SHOREHAM NUCLEAR POWER STATION

Safety Evaluation Report Issue No. 8  
Dynamic Qualification  
Shoreham Nuclear Power Station - Unit 1  
Docket No. 50-322

## GENERIC ITEMS

Fig. E-6 Comparison of ANSYS and RACKOE for Vertical Support Forces and Base Moments

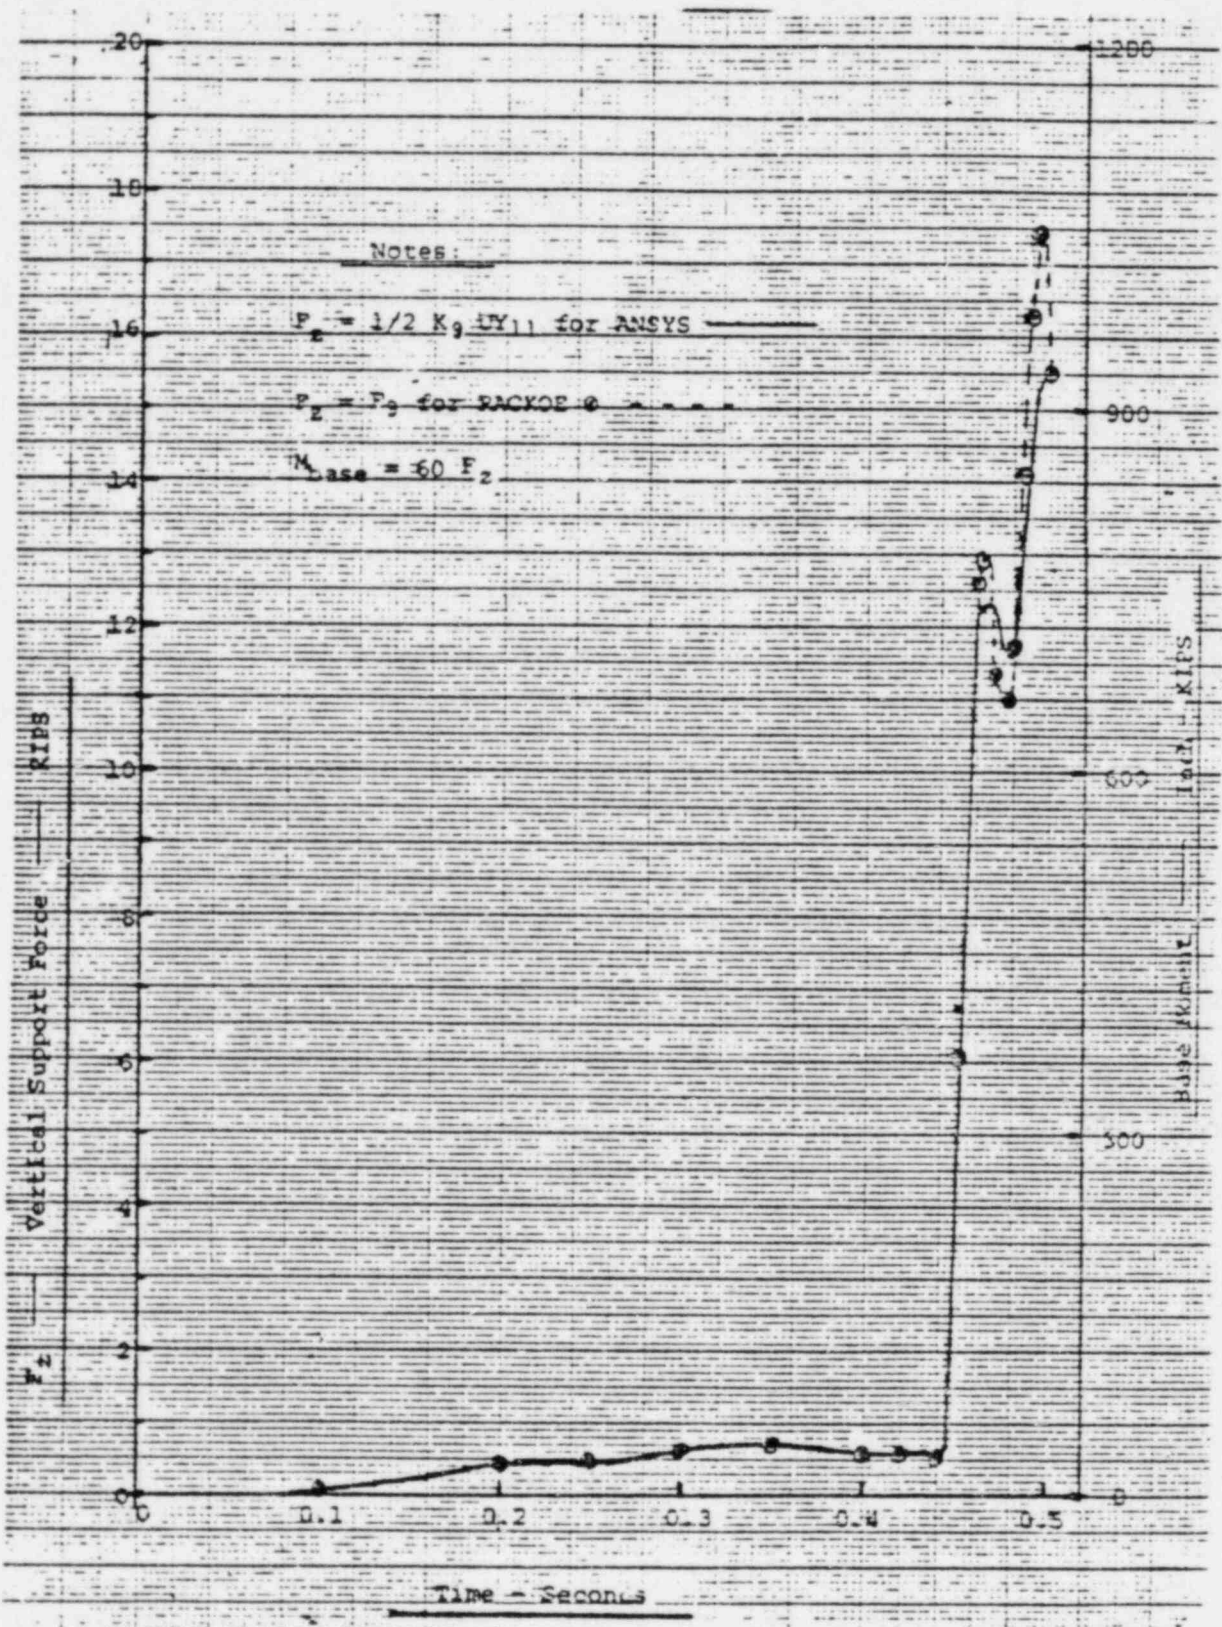
2. Permanent Control Rod Storage Rack - 1F16\*RAK-23  
Package No. SH1-427-1
  - a. The qualification loads report was not available in the SQRT file. Need clarification
  - b. Provide evidence of verification for the non-linear analysis code used.
  - c. Loads were not properly defined (i.e., a time history was used, but there was no description of what it represented). Provide clarification.

Figure E-1 shows the model used for checking RACKOE against the more general structural analysis program ANSYS (Ref. E3). To verify the essential feature of RACKOE everything except structural damping in eq. (E-5), ANSYS was run only until and slightly after a fuel contact occurred. As input, both programs used the input ground acceleration shown in Fig. E-2. For completeness, the absolute ground displacement is shown.

Considering the detailed agreement between ANSYS and RACKOE in this comparison run, the basic one stick fuel impact model is considered verified. Various options of RACKOE are discussed and justified in attachments to this appendix.

FIG. 1. LOCKING PLATE IN POSITION ON COUPLING  
END PEDESTAL FOOT BEFORE LOCKING

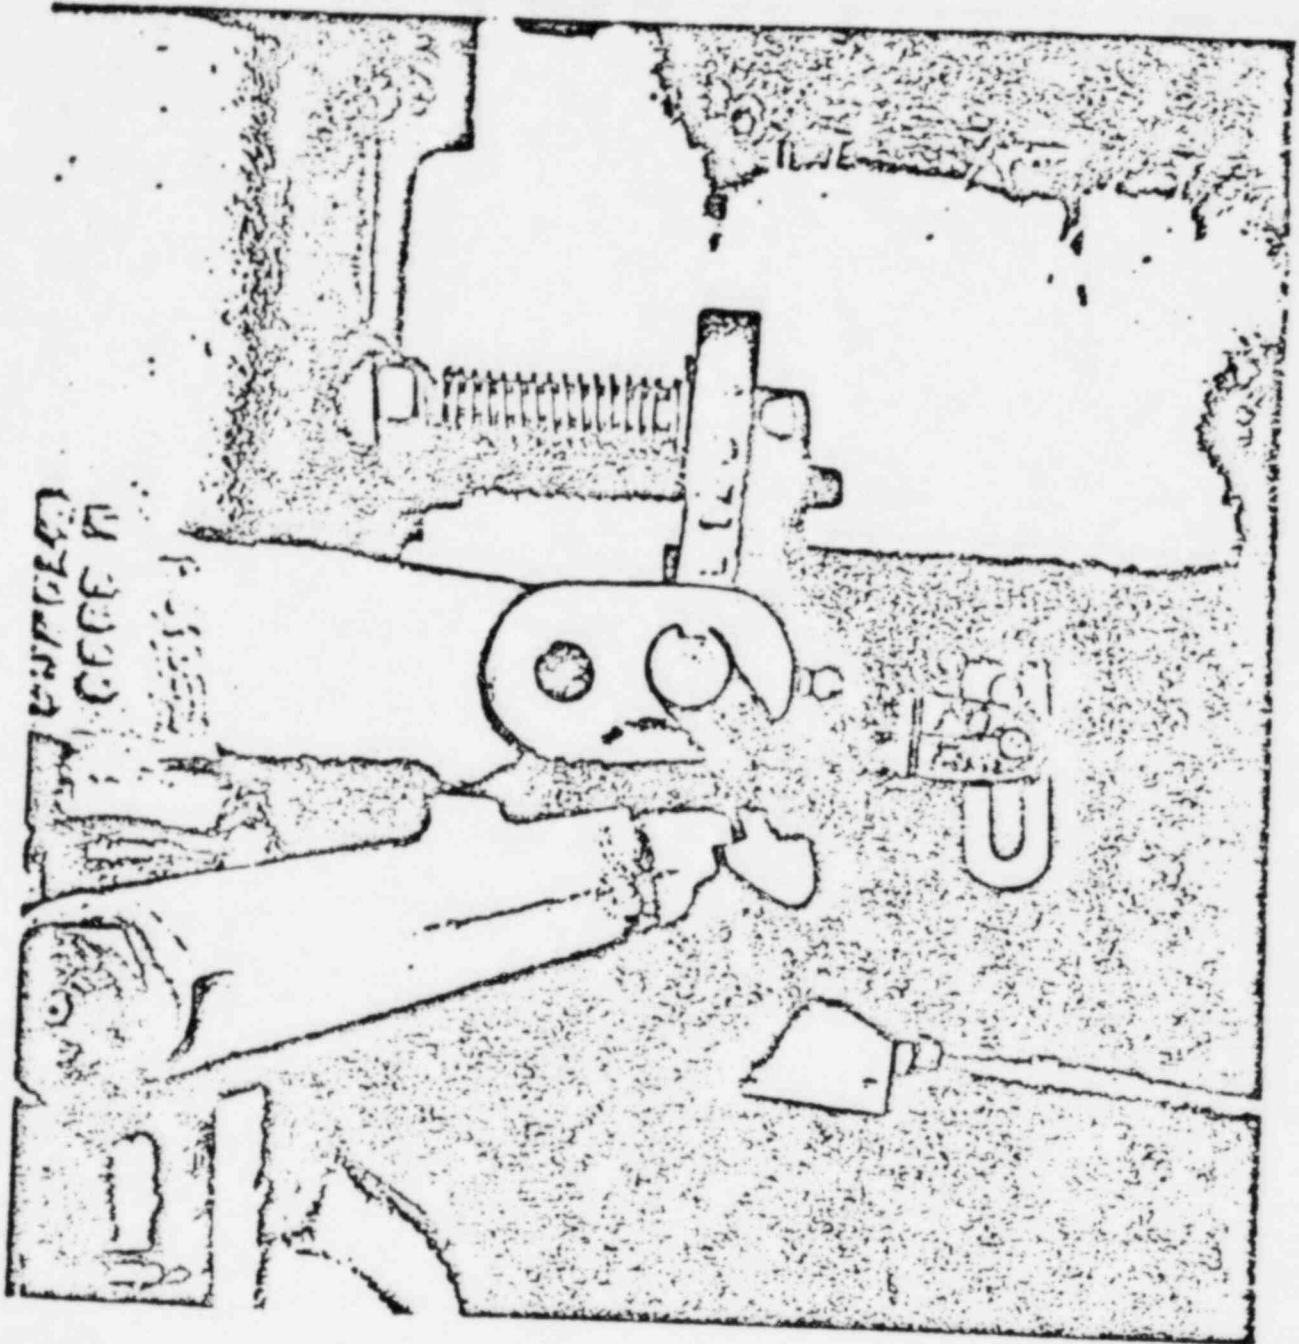
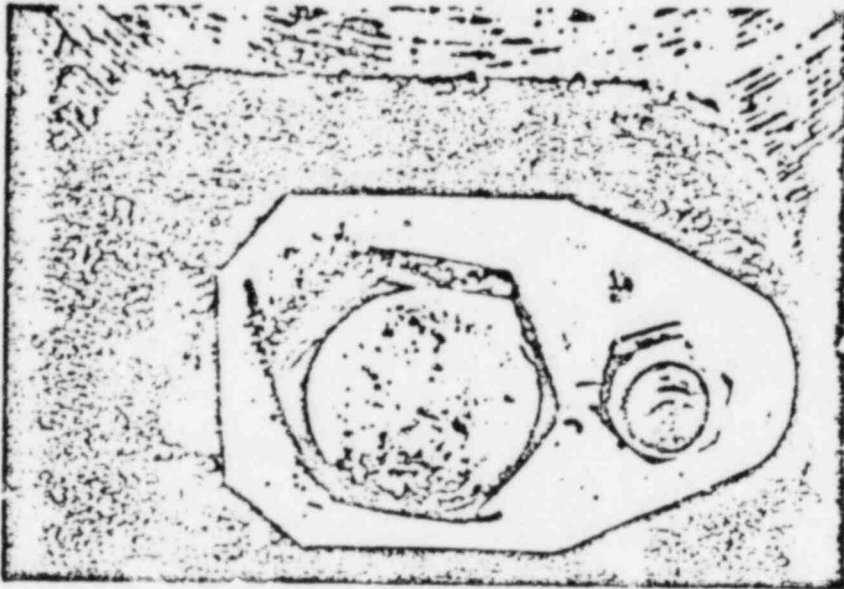
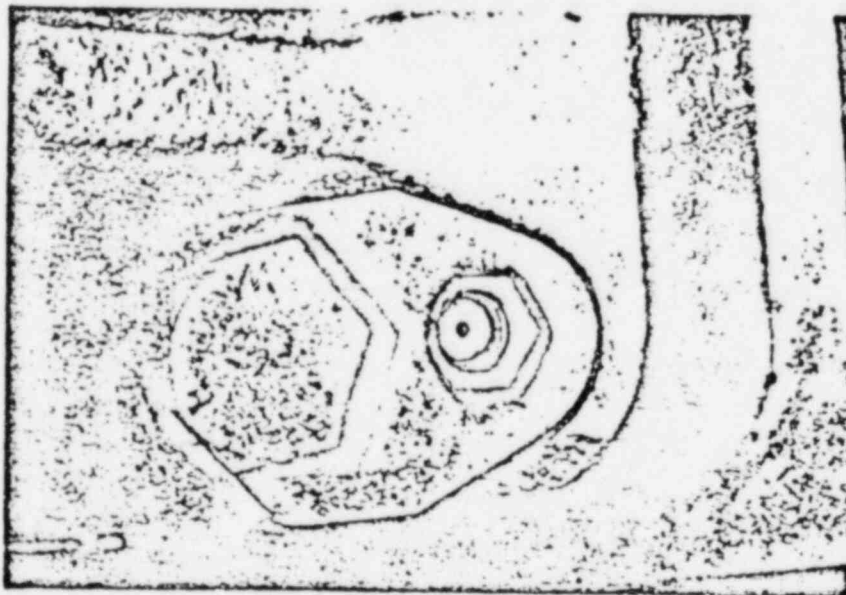
- a. The turbine in the plant (GS-1) is not the same as the one in the test report (GS-2). Establish dynamic similarity.
- b. Since the qualification is dependent on some modifications, report to the NRC when implementation of the modifications is completed.

**ACTION:** Consideration should be given to the modification to install #9 pins and pedestal bolt lock plates. FDI 114-88524 will be issued to define this installation.

With reference to vendor drawing 111904C, attached, inspect the turbine assembly for installation of the #9 taper pins and use of the positive lock tabs on the coupling end bearing pedestal hold-down bolts. If not in compliance, the following corrective action is required:
